DESCRIPTION OF PROPOSED CHANGE NPF-10-7 AND SAFETY ANALYSIS
AMENDMENT APPLICATION NO. 3 OPERATING LICENSE NPF-10

DESCRIPTION OF PROPOSED CHANGE NPF-10-10 AND SAFETY ANALYSIS
AMENDMENT APPLICATION NO. 3 OPERATING LICENSE NPF-10

DESCRIPTION OF PROPOSED CHANGE NPF-10-11
AND SAFETY ANALYSIS AMENDMENT APPLICATION NO. 3
OPERATING LICENSE NPF-10

figure 6.2-3

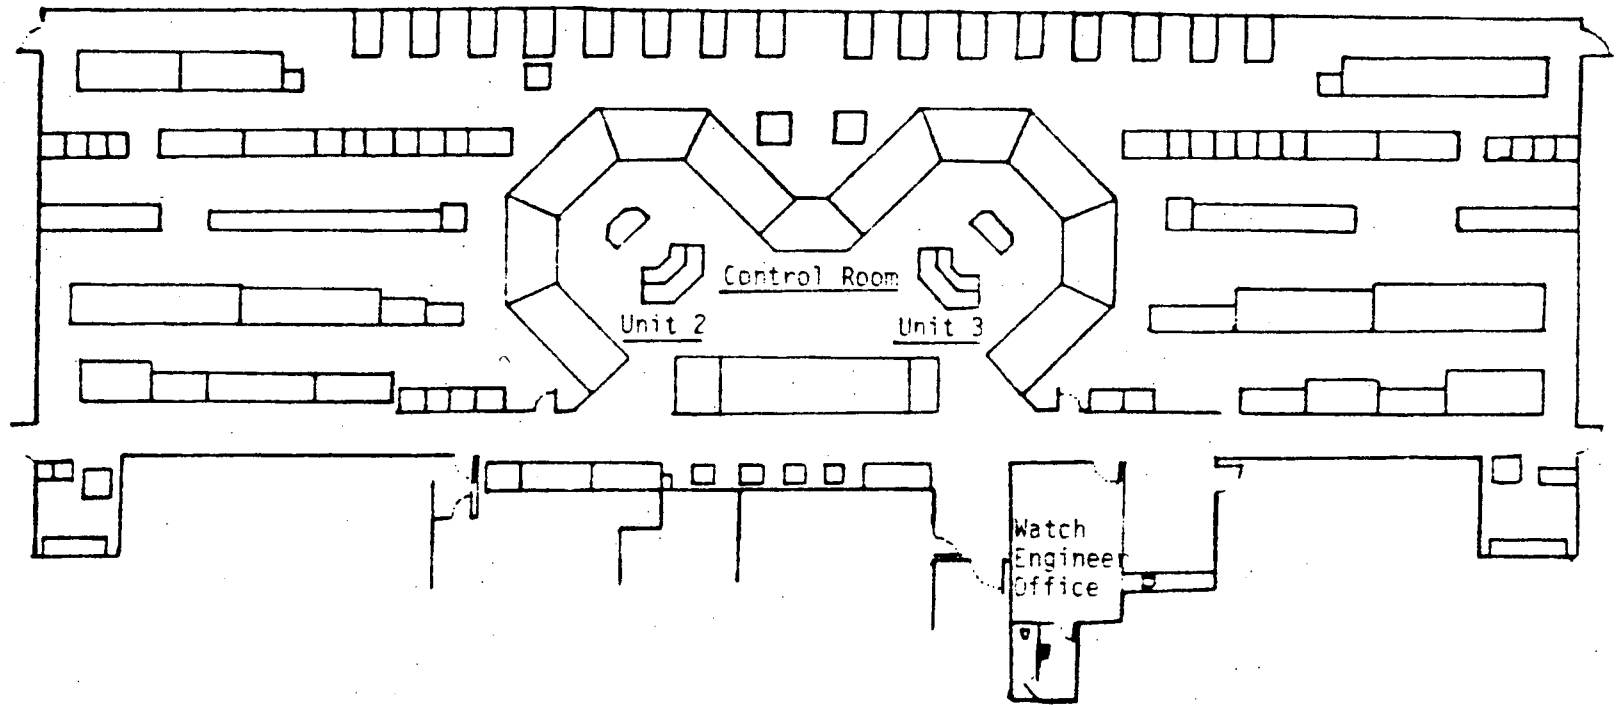
Proposed change to Technical Specification 6.2.2, Figure 6.2-2 is contained in Attachment "B". Technical Specifications 6.1.2, 6.2.2.e, Table 6.2-1 and Figure 6.2-3 are changed to "Shift Supervisor" from "Watch Engineer." The proposed change to the applicable paragraphs of Technical Specifications 6.5.2, 6.5.3, and 6.8.2 are as follows:
